Western Digital Corporation
 5863 Rue Ferrari
 San Jose, CA, 95138

To: T10 SAS Protocol Working Group
 Contact: Mark Evans
 Phone: 408.363.5257
 Email: mark.evans@wdc.com
 Date: [07 October 2008](#)

Subject: [SAS-2.1 / SPL](#), Low power transceiver options, phy states

Figure a — PS (phy layer) state machine - SAS phy power management states

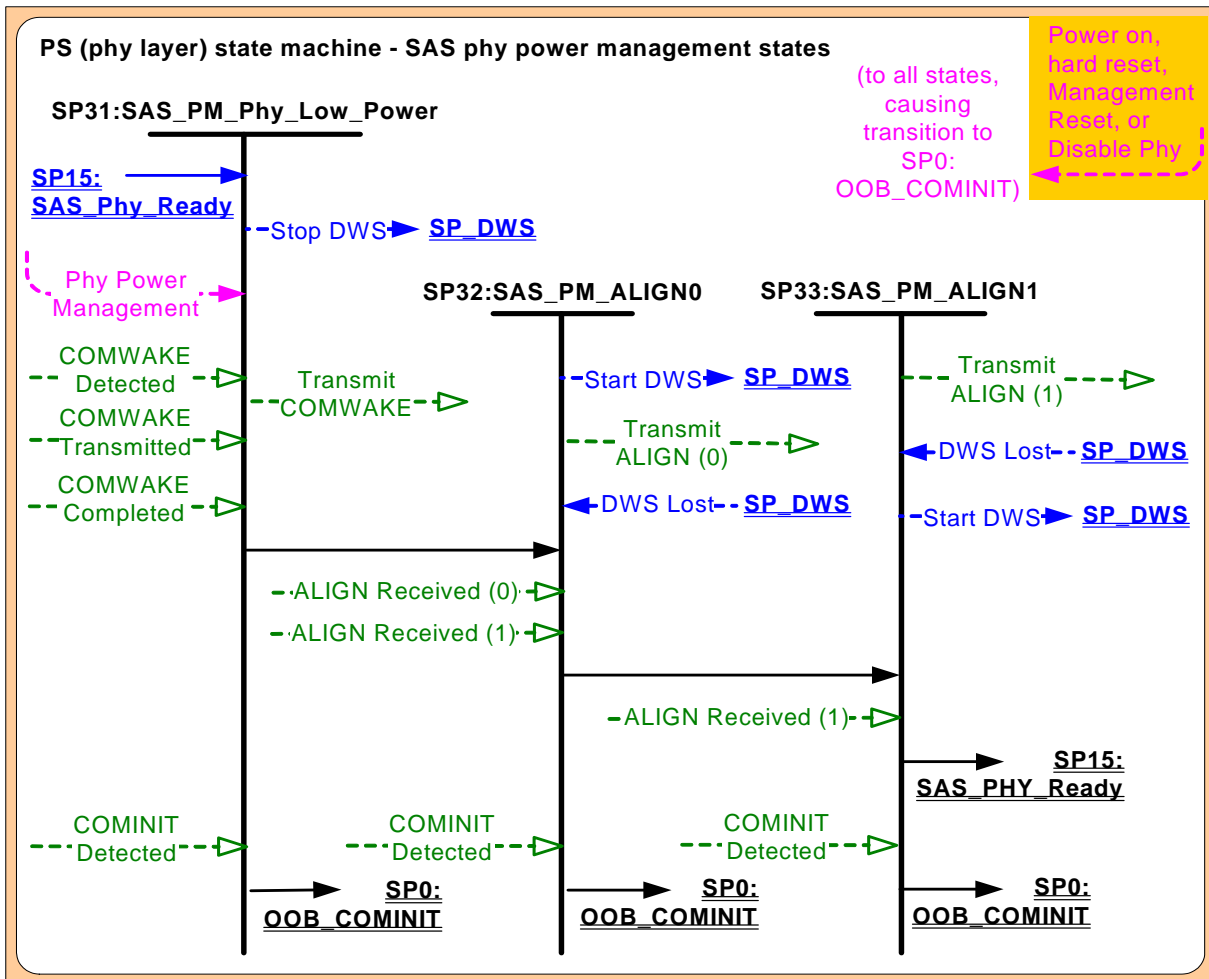
[Editor's note: this is a new clause with a new figure.]

Figure a shows the SAS phy power management states. These states are entered when a phy enters a low power condition (i.e., the SAS partial low power condition or the SAS slumber low power condition) and process the actions that return a phy from a low power condition to participating in an operational logical link. These states are indicated by state names with a prefix of SAS PS.

6.8.5.2 SP31:SAS PS Phy Low Power state

Upon entry into this state, this state shall send a Stop DWS message.

If this state is entered with a Partial argument, then:

- a) the phy shall enter in the Partial power condition (see [add a cross reference to a clause where this is defined in 08-015]); and
- b) the state shall set the SASPhyPwrMgmt state machine variable to Partial.

If this state is entered with a Slumber argument, then:

- a) the phy shall enter in the Slumber power condition (see [add a cross reference to a clause where this is defined in 08-015]); and
- b) the state shall set the SASPhyPwrMgmt state machine variable to Slumber.

If this state receives a Phy Power Management (Exit) request or a COMWAKE Detected message, then this state shall send a Transmit COMWAKE message.

6.8.5.2.2 Transition SP31:SAS PS Phy Low Power to SP0:OOB COMINIT

- a) this state:
 - A) receives a COMWAKE Transmitted message; and
 - B) does not receive a COMWAKE Completed message within a hot-plug timeout (see table 93 in 6.7.1);
- or
- b) this state receives a COMINIT Detected message.

6.8.5.2.3 Transition SP31:SAS PS Phy Low Power to SP32:SAS PS ALIGN0

- a) receives a COMWAKE Transmitted message; and
- b) receives a COMWAKE Completed message.

6.8.5.3.2 Transition SP32:SAS PS ALIGN0 state to SP0:OOB COMINIT

- a) receives a DWS Lost message, if this state does not send a Start DWS message;
- b) receives a COMINIT Detected message; or
- c) does not receive an ALIGN Received (0) message or an ALIGN Received (1) message before the SNLT timer expires.

6.8.5.3.3 Transition SP32:SAS PS ALIGN0 to SP33:SAS PS ALIGN1

- a) if this state receives an ALIGN Received (0) message or an ALIGN Received (1) message before the SNLT timer expires; and
- b) after this state has sent at least three Transmit ALIGN (0) messages.

6.8.5.4.2 Transition SP33:SAS PS ALIGN1 state to SP0:OOB COMINIT

- a) receives a DWS Lost message, if this state does not send a Start DWS message;
- b) receives a COMINIT Detected message; or
- c) does not receive an ALIGN Received (1) message before the SNLT timer expires.

6.8.5.4.3 Transition SP33:SAS PS ALIGN1 state to SP15:SAS PHY Ready

- a) if this state receives an ALIGN Received (1) message before the SNLT timer expires;
- b) after this state has sent at least three Transmit ALIGN (1) messages; and
- c) after this state sets the SASPhyPwrMgmt state machine variable to Active.
